MISSOURI PUBLIC SERVICE COMMISSION

STAFF REPORT ON

**ELECTRIC UTILITY RESOURCE PLANNING
COMPLIANCE FILING**

FILE NO. EO-2021-0021

Figure 2.5 Capacity Price Assumptions

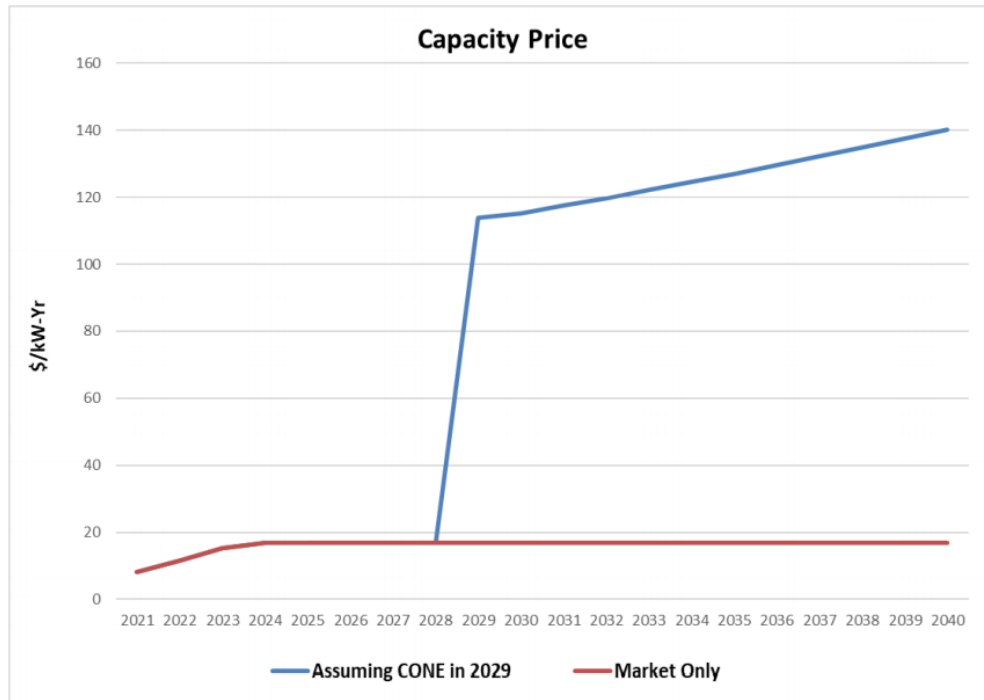
Ameren Missouri is not analyzing and considering non-renewable supply-side resources on an equivalent basis with renewable supply-side resources or demand-side resources as demonstrated by the following excerpt from Chapter 9 of Ameren Missouri’s IRP filing:

Ameren Missouri correctly limits non-renewable supply-side resource additions to periods of projected capacity needs. Furthermore, Ameren Missouri staff has identified that 300 MW is a “reasonable level of capacity market dependence” while simultaneously proposing to implement vast demand-side resource programs and invest in thousands of megawatts of renewable resources regardless of the need to do so. These differences in methodologies do not allow the resources to be considered and analyzed on an equivalent basis and can have a drastic impact on the estimation of net present value of revenue requirement (“NPVRR”) because ***

In contrast, “a separate capacity price curve was also developed to be used in future demand-side resource cost effectiveness analyses.”¹¹ This “separate capacity price curve” should be dismissed as it does not realistically reflect costs which may be avoided resulting from implementation of demand-side resources and has the potential to artificially inflate “proposed benefits” of future demand-side programs. Furthermore, the demand-side resources included as options within this analysis were screened utilizing avoided capacity costs which were much higher than not only the “market only curve” but also the “separate capacity price curve.” This likely resulted in demand-side programs and measures being included which may not have been deemed cost effective when utilizing the “market only curve.” This would also have an impact on the resulting NPVRR of any given plan. Graph 1 below illustrates the differing capacity costs utilized by Ameren Missouri for various resource types within the triennial filing.

Graph 1: Capacity Cost

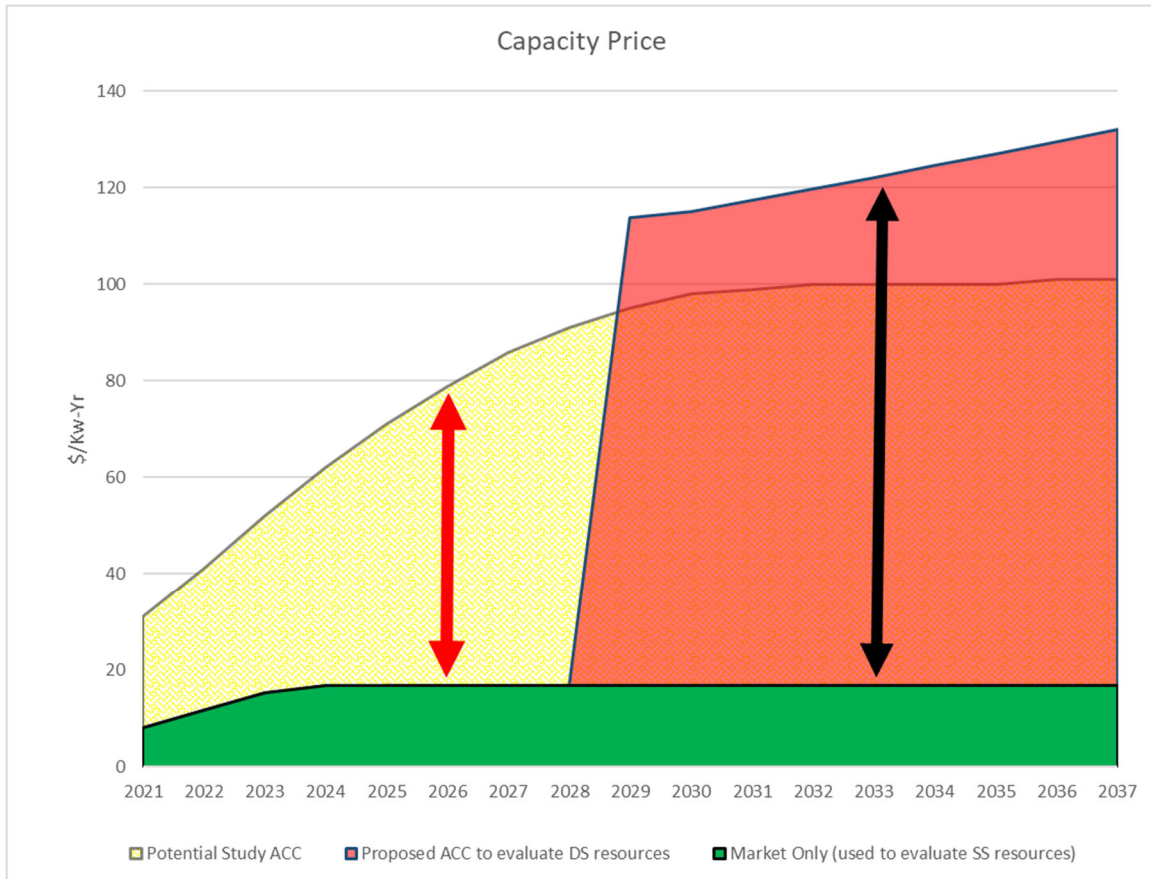
The black arrow in Graph 1 reflects the difference between the capacity value of supply-side resources within Ameren Missouri’s integrated analysis and the capacity cost that Ameren Missouri is proposing to utilize to evaluate future demand-side resources. This drastic difference in valuation of demand-side resources as compared to the valuation of supply-side resources does not allow the two types of resources to be evaluated on an equivalent basis. See Concern B below for the discussion of the red arrow.

To remedy this deficiency, Ameren Missouri should utilize the “market only” capacity cost curve when evaluating any future demand-side resources in order to evaluate supply-side resources on an equivalent basis as demand-side resources. Ameren Missouri should also provide analysis quantifying all savings resulting from the implementation of the demand-side resources within the preferred resource plan that can reasonably be expected to avoid costs to ratepayers through concrete verifiable reductions in rates. This analysis should include evidence of reduced

MISO costs and expected revenue from excess capacity sales. Furthermore, Ameren Missouri should maintain build thresholds for non-renewable supply-side resources as well as renewable supply-side resources and demand-side resources based upon the projected capacity need for reserve requirements.
